Division Street Pavement and Storm Rehabilitation

DATE: March 8, 2021

ADDENDUM NO. 1

SHEET NO. 5

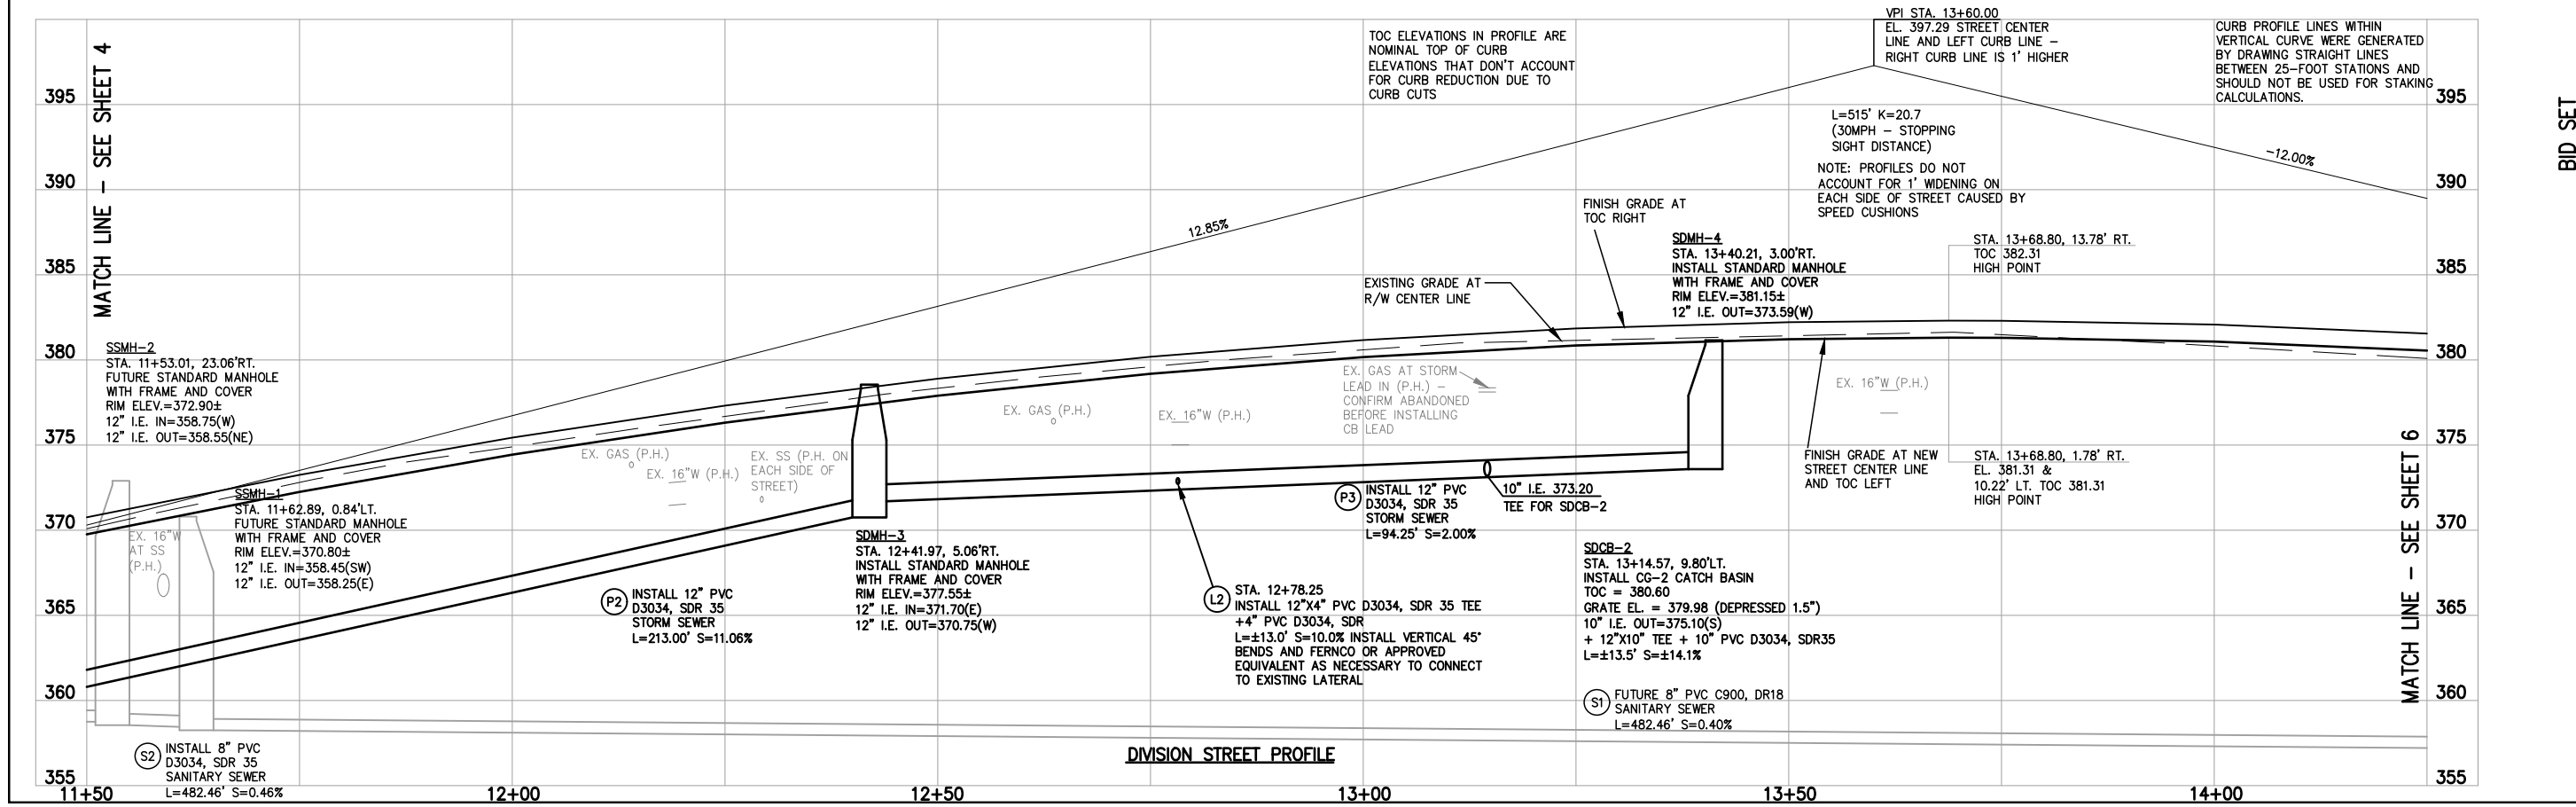
3. See attached revised plan sheet (Sheet 5) showing a power service line within SW Division Street serving the house at 15181 SW Division Street.
